RIO BUENA VISTA WATER AND SEWER SYSTEM
EVALUATION & RECOMMENDATION OF ACTION

APRIL 16, 2025

VALVE BOX INSTALLATION

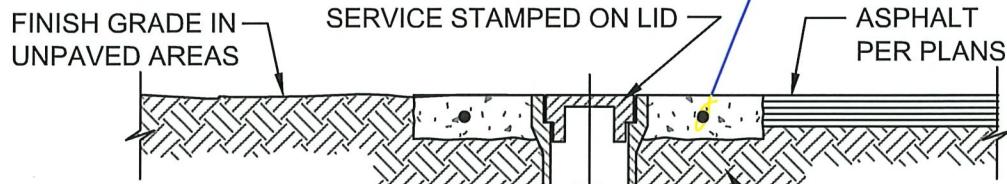
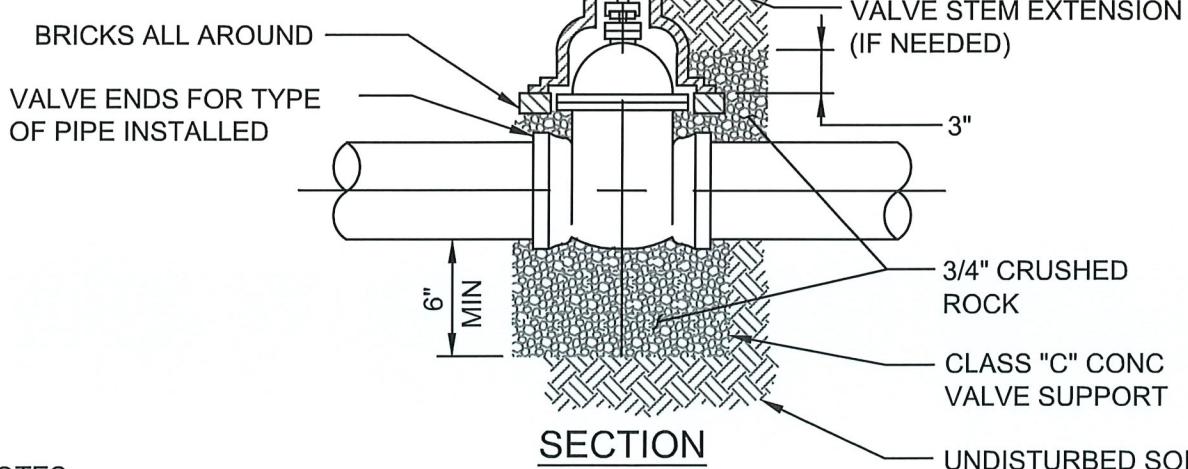
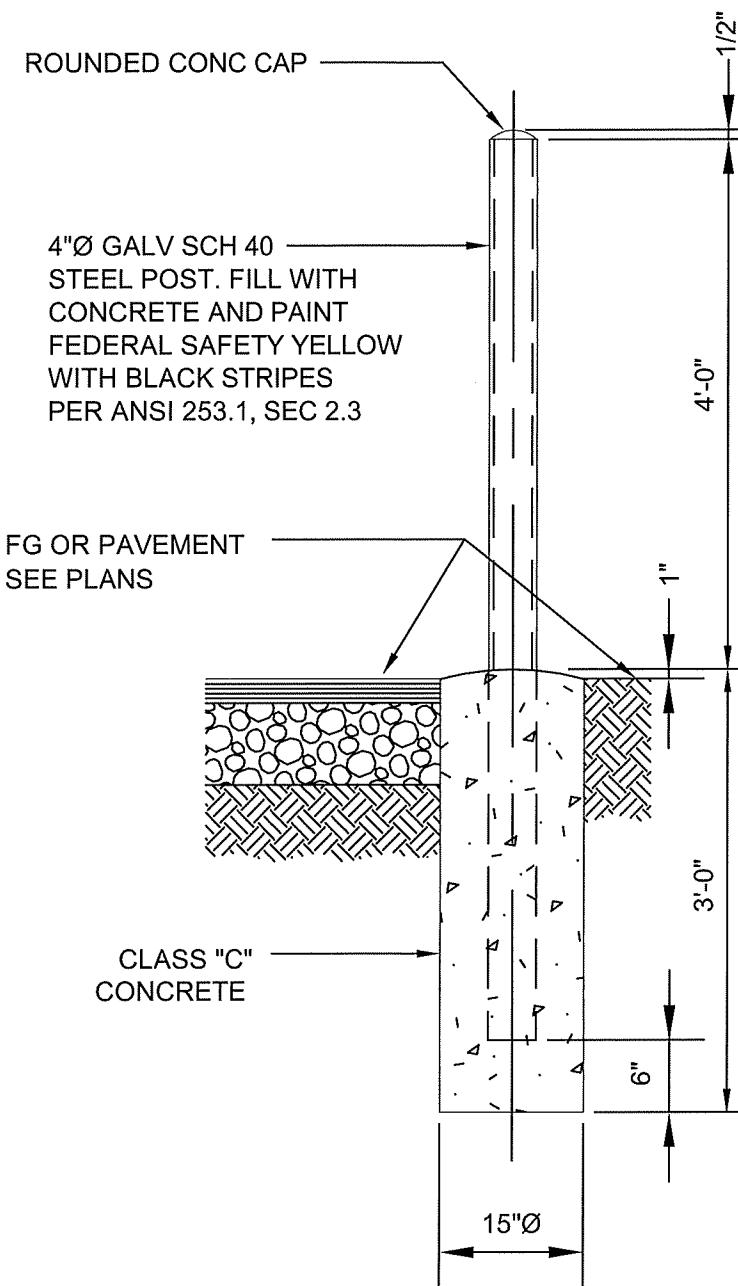
2022 Study: Recommended an additional new isolation valve be installed in Beach Drive near the parking lot in the center of the development.

Action: The Association still need to take this action. Attached is a typical valve installation detail that needs to be used for installation of this valve.

GUARD POST

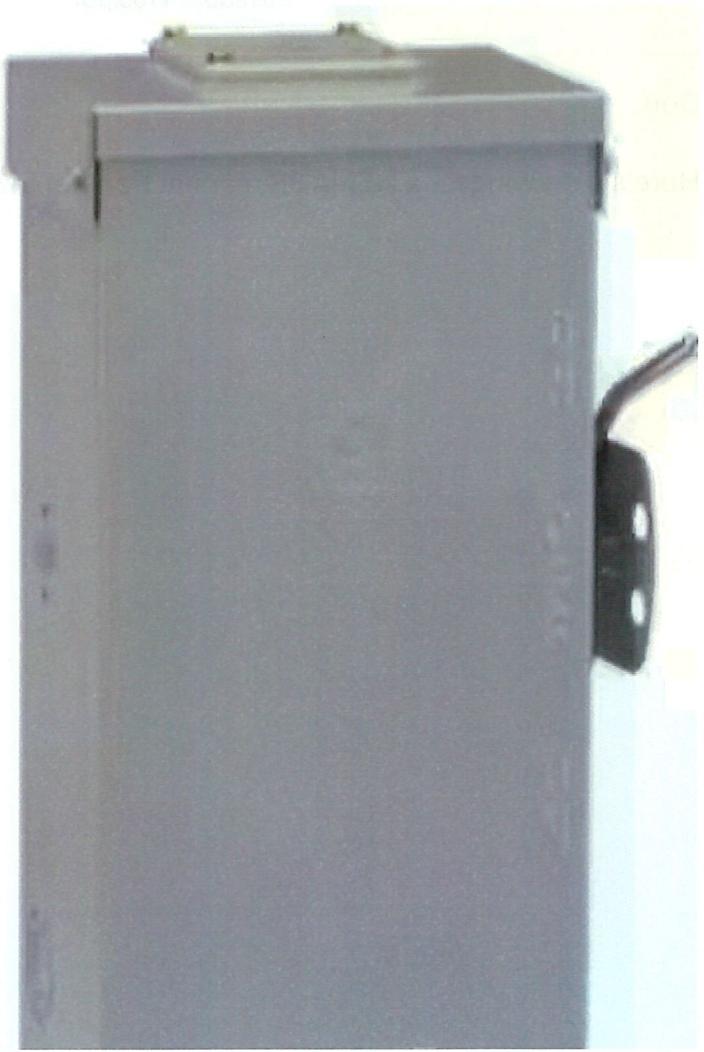
2022 Study: Recommend installation of (4) pipe bollards, one on each side of the sewer lift station to provide protection against the accidental damage by a vehicle driving over the pump station.

Action: We support the installation of the protective pipe bollards on each side of the lift station. Attached is a detail showing the installation of a typical bollard.

100 Amp 240-Volt Non-Fused Emergency Power Transfer Sw

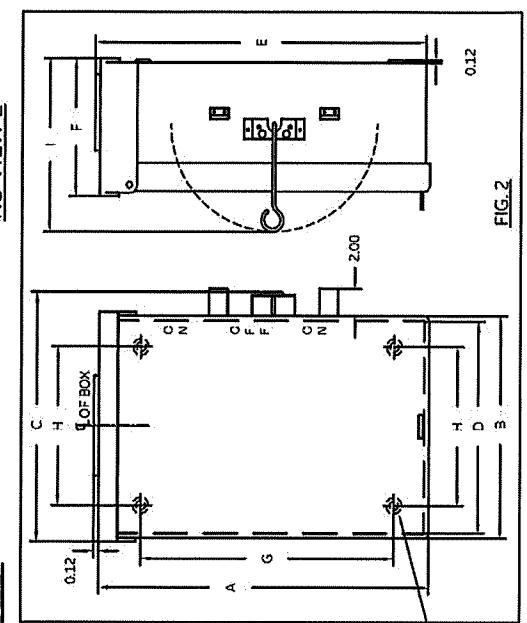
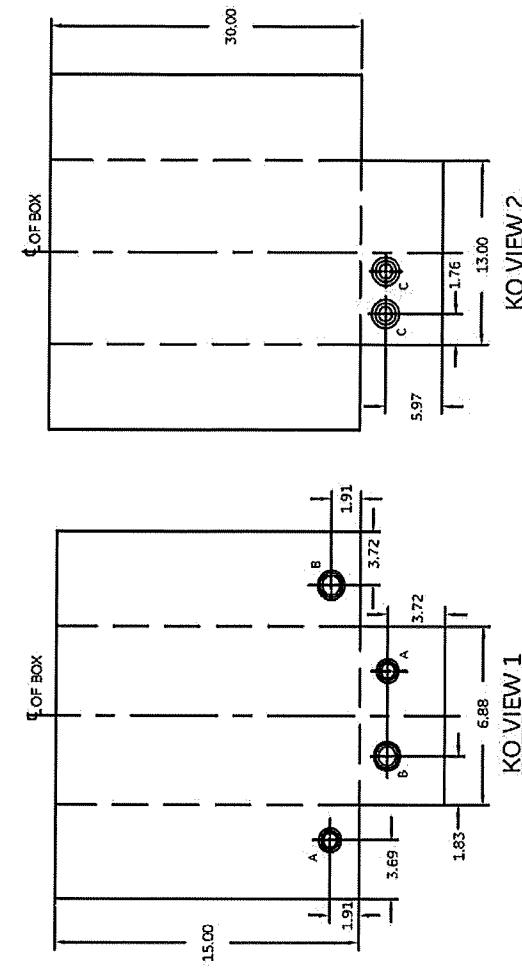
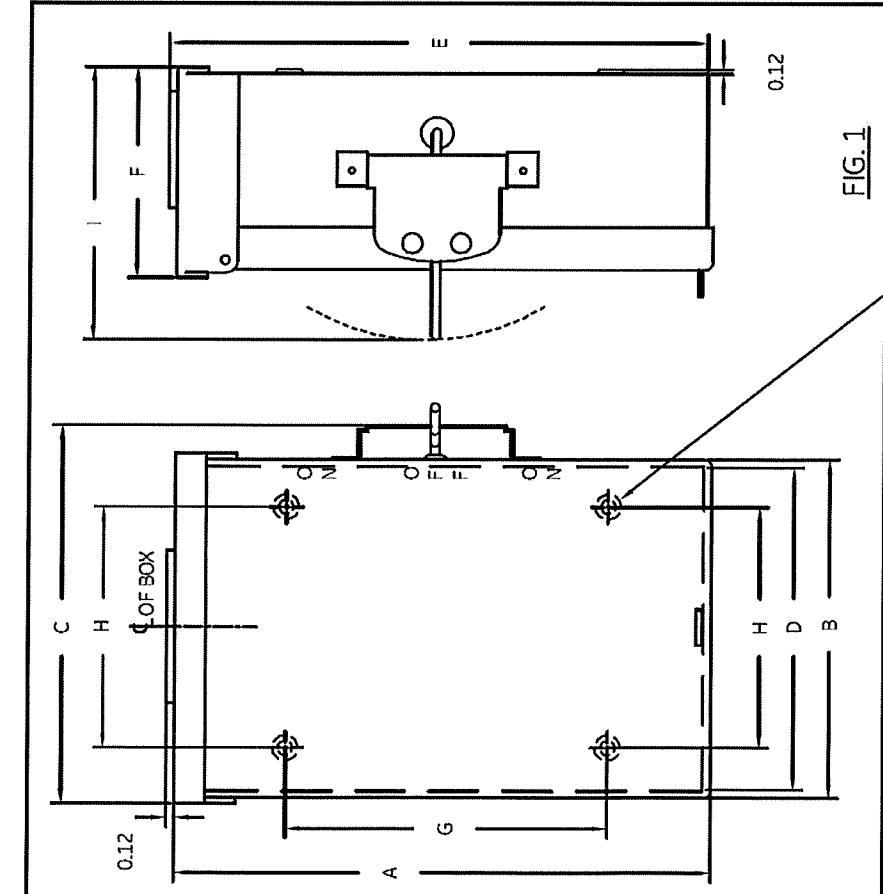
2002 Study: The study recommended installation of a manual transfer switch to facilitate connection of a City owed backup generator in the event of a delayed power outage.

Action: The Association still needs to install a manual transfer switch connected to the existing power supply and pump control panel. We would recommend the following:

- Sized for the amp rating of the main disconnect serving the lift station. (Thus, rated to power both pumps).
- Outdoor weather enclosure.
- Work to be performed by a licensed electrical contractor.
- Need to coordinate the connection blocks that match the City's portable stand-by generator
